Libby Asbestos Project, Operable Unit 1

Change / Modification Log

OU1 Design Change and Modification Sheet: Change/Modification #1

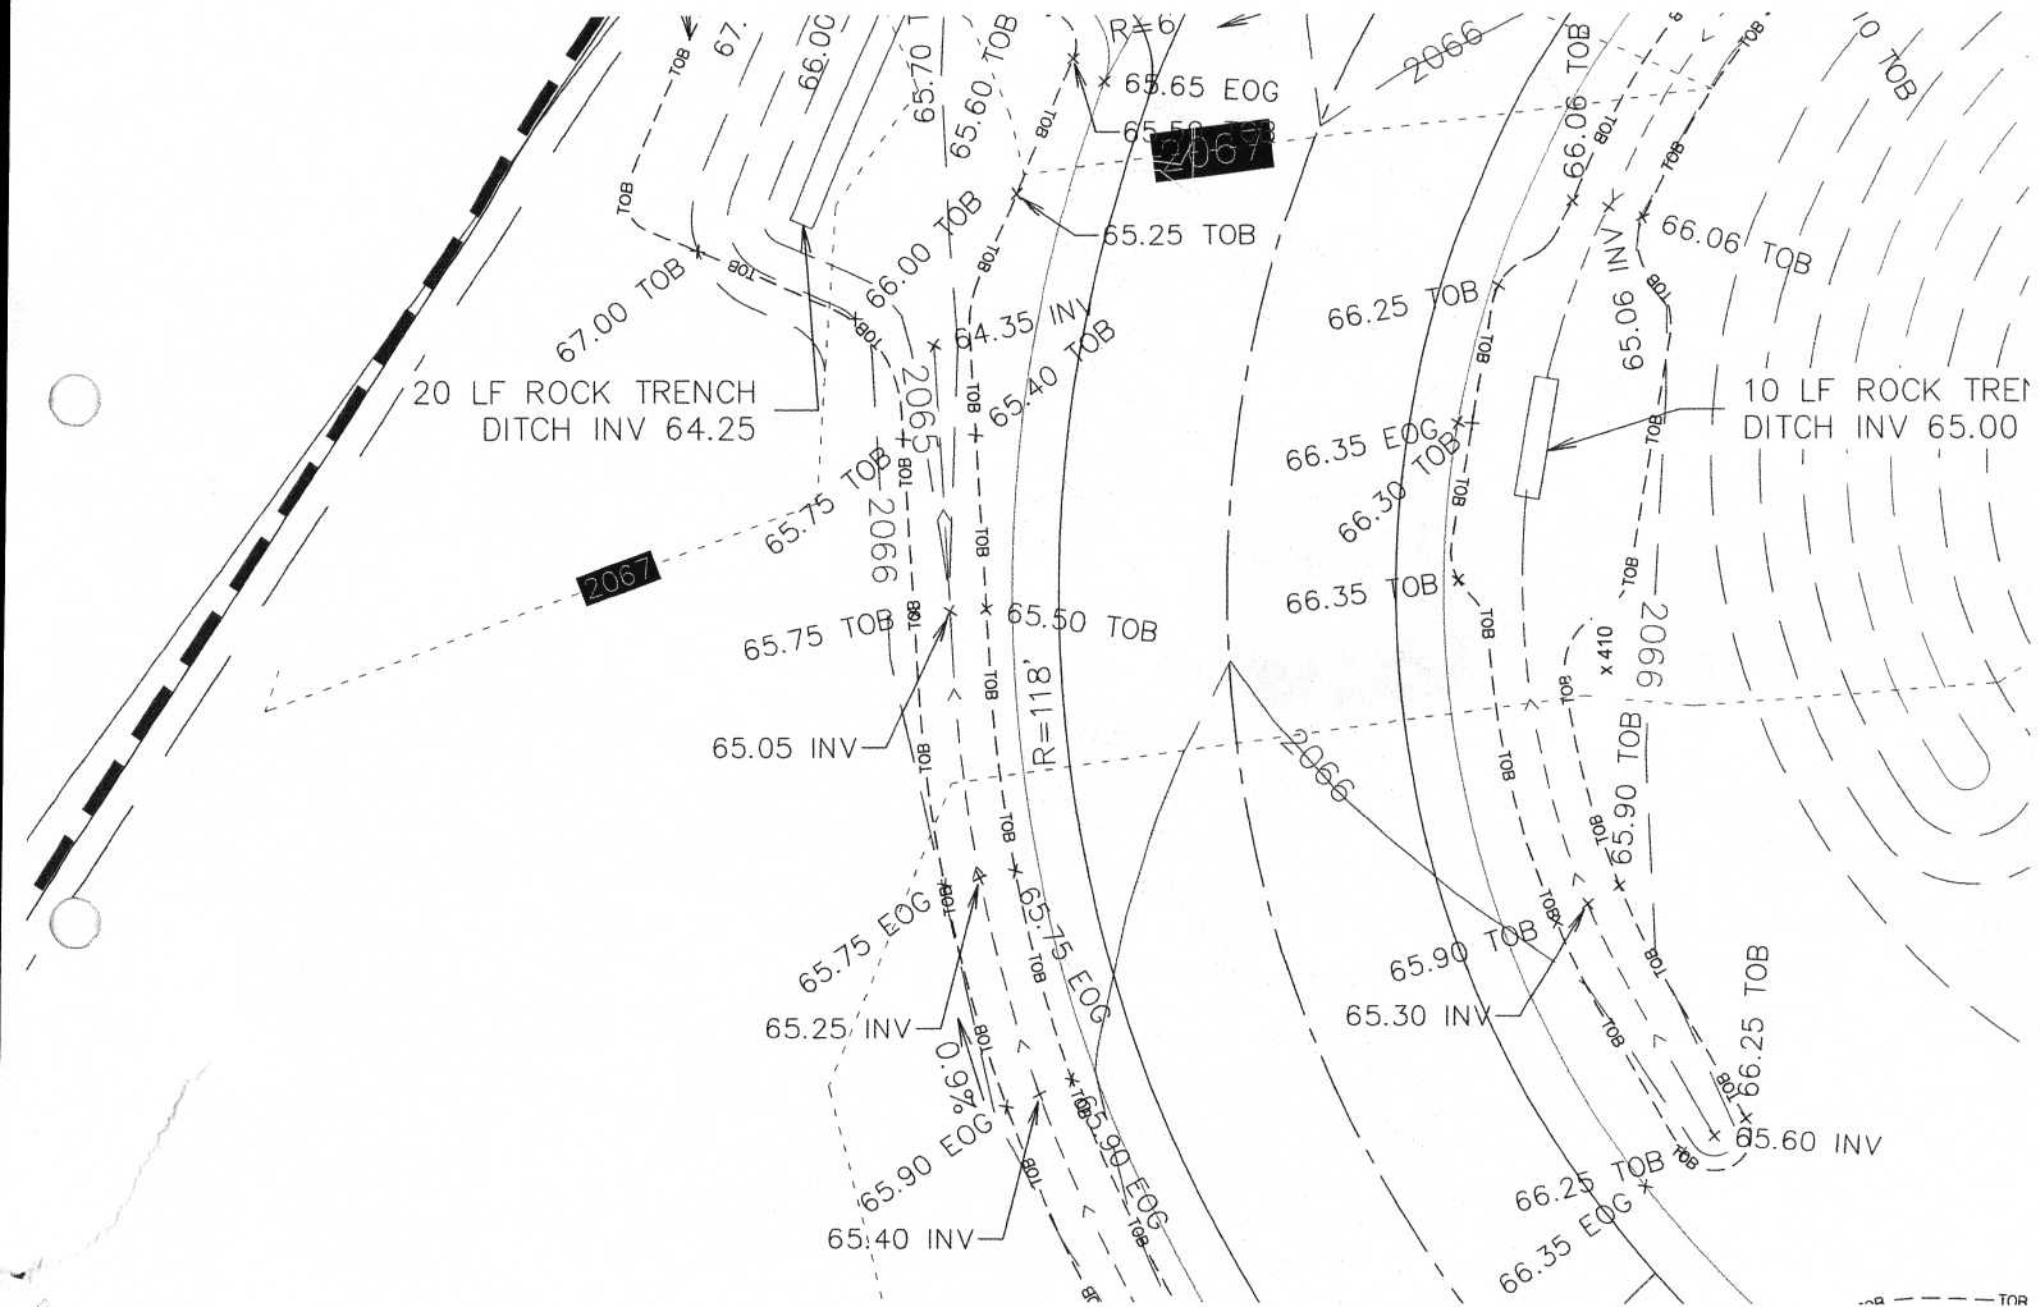
Elevation point 410 (Sheet C4) was identified by the surveyors as being deeper than it should be. HFS requested a clarification from CDM Engineer, Karin Mainzhausen. Karin stated that the point in question must be "CAD" glitch and suggested that the point be disregarded and the WGM points for the TOB and the rock trench (Detention Basin) invert be used. Ms. Mainzhausen has provided a PDF with the WGM points. The communication from Ms. Mainzhausen and the referenced PDF have been attached to this document.

The surveyors are requesting a clarification for the elevation associated with point 410. It appears that this point is deeper than what it should be.

Please look at the elevation data to see if there is an apparent issue.

I looked at the WGM file and I suggest that the surveyors disregard point 410 and use the WGM points for the TOB and the Rock trench invert. I attached a pdf with their points. These points are FG and 1.5 ft have to be subtracted to get the subgrade surface. Jim Davis has these points from the WGM xml that I sent them. If you need the coordinates of each point, we can get them to you.
